## MEMORANDUM

**SUBJECT:** BZA Case 19844 (1033 16<sup>th</sup> Street NE): to permit construction of a flat in the RF-1 zone, requiring area variance relief pursuant to Subtitle X § 1000.1 from the minimum lot dimensions, side yard, and front yard requirements of E §§ 202.1, 307.1, B § 305.1 respectively, and special exception relief from the penthouse requirements of Subtitle C §§ 1500.4 and 1502.2

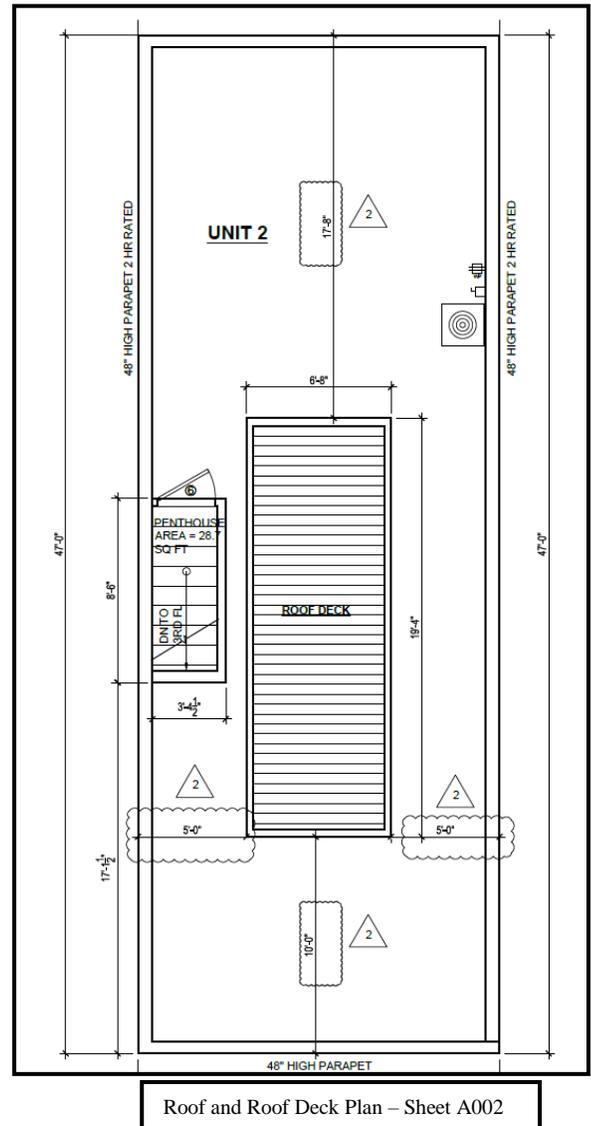
The penthouse is not set back from the roof edge as required. Rather, it is located along the east lot line. Front and rear setbacks are compliant.

Construction of the penthouse to meet the required setback from the side building walls of the roof would be impractical due to the width of the lot.

The relief requested would result in a more efficient floor design below, allowing the stairs to abut the interior side wall, which is typical for row dwellings. The penthouse should not appear to be an extension of the building wall, as it would only be 8 feet 6 inches in length along the 47-foot southern elevation, and a four-foot parapet would be placed above the roof line's perimeter, as shown in the drawings on Sheet A004.

Approximately four feet of the penthouse would project above the 4 feet tall parapet. It may be visible from the north along 16<sup>th</sup> Street, due to the undeveloped lot and alley abutting the subject property. However, this visibility should not be permanent since the adjacent lot would be developed in the future. The penthouse would not be visible directly from the 16<sup>th</sup> Street frontage, as it is setback ten feet from the roof's edge at the front and 17 feet from the roof's edge at the rear. The four-foot parapet around the roof edge's perimeter should minimize the penthouse's visibility.

As stated prior, placing the stairwell in this location would help achieve reasonable efficiencies in Unit 2's floor layout below. Placement of the penthouse away from the sidewalls would still require relief, as full compliance for a penthouse could not be provided based on the lot's width at 16.97 feet.
